**Pacific Gas and
Electric Company**

PG&E Letter DCL-04-149

Docket No. 50-275, OL-DPR-80
Docket No. 50-323, OL-DPR-82
Diablo Canyon Units 1 and 2
License Amendment Request 04-07
Revision to Technical Specifications 3.7.17 and 4.3 for Cycles 14-16 for a Cask Pit
Spent Fuel Storage Rack

FIGURE 3.7.17-1
ALLOWABLE STORAGE CONFIGURATIONS
(ALL CELL, 2X2 ARRAY, CHECKERBOARD)
FOR THE PERMANENT SPENT FUEL POOL STORAGE RACKS

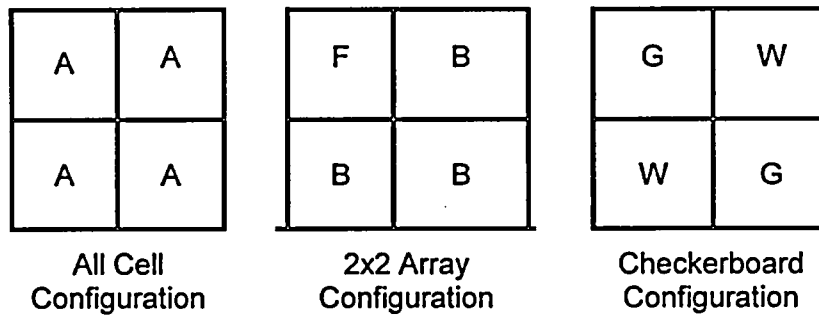
1. TS 3.7.17: LCO 3.7.17 would be revised to add requirements during Cycles 14-16 for a cask pit rack.
2. Figures 3.7.17-1 to 4: Figures 3.7.17-1 to 3 would be changed to note that they are applicable to the permanent storage racks. Figure 3.7.17-4 would be added to provide acceptable/unacceptable enrichment and burnup requirements for the fuel stored in the cask pit rack for Cycles 14-16.

FIGURE 3.7.17-4
 MINIMUM REQUIRED ASSEMBLY DISCHARGE BURNUP
 AS A FUNCTION OF INITIAL ENRICHMENT
 FOR SPENT FUEL STORAGE IN THE CASK PIT STORAGE RACK

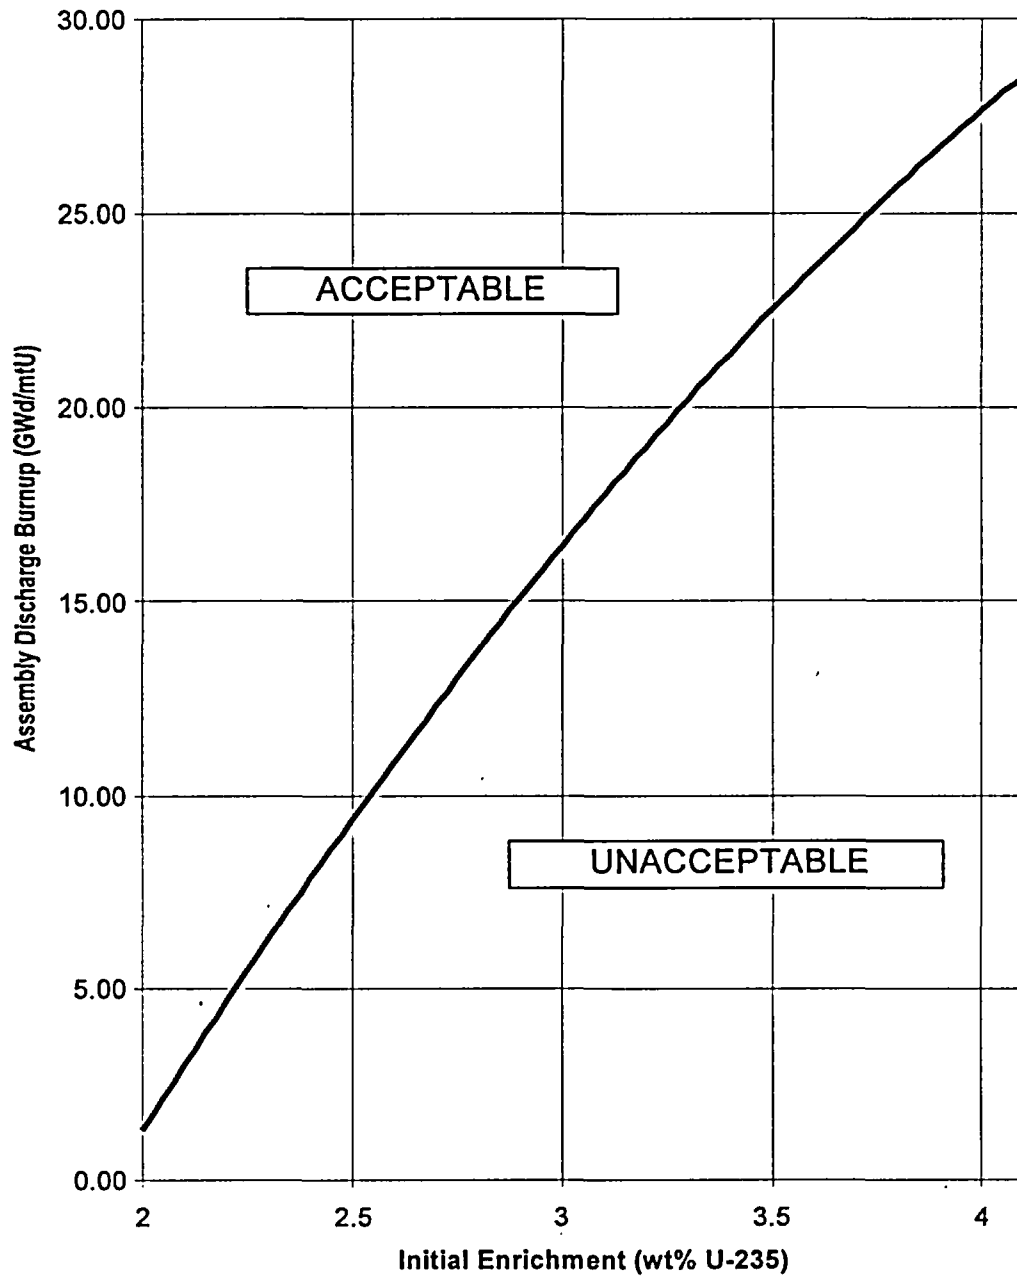
Insert New Figure 3.7.17-4.
